MEMORANDUM

From:	Brigitte Crafer Landscape Architect		
Service	WBC Landscape and Trees	App No:	241900 Rev. A
Address:	Land South of Old Bath Road Sonning, RG4 6GQ.		
Proposal:	Application to vary condition 2 of planning consent 220663 for the proposed erection of 57 dwellings suitable for older persons accommodation following demolition of the existing dwellings (Access, Layout, Scale and appearance to be considered). Condition 2 refers to approved plans and details and the variation is to change the site layout and associated details.		
Type of Development:	Major Dwellings (10+)		
Site Visit Made:	Yes/No

Fig. 2 – Re-configuration of garden area between Block A and B and revised parking arrangement, showing 5th parking bay and impact on T68

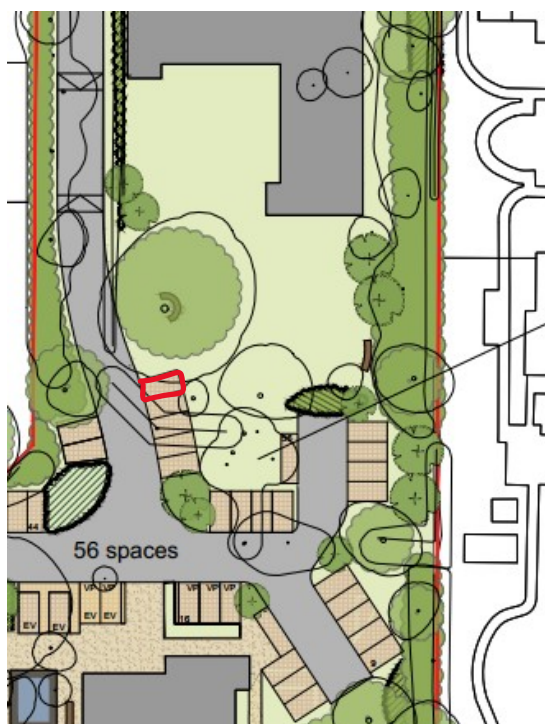
This is an improvement on the previous arrangement but there is still more of an incursion into the RPA of T68 by the northern parking bay of 5 – and this is more incursion into another protected tree which is unnecessary and needs to be reviewed.
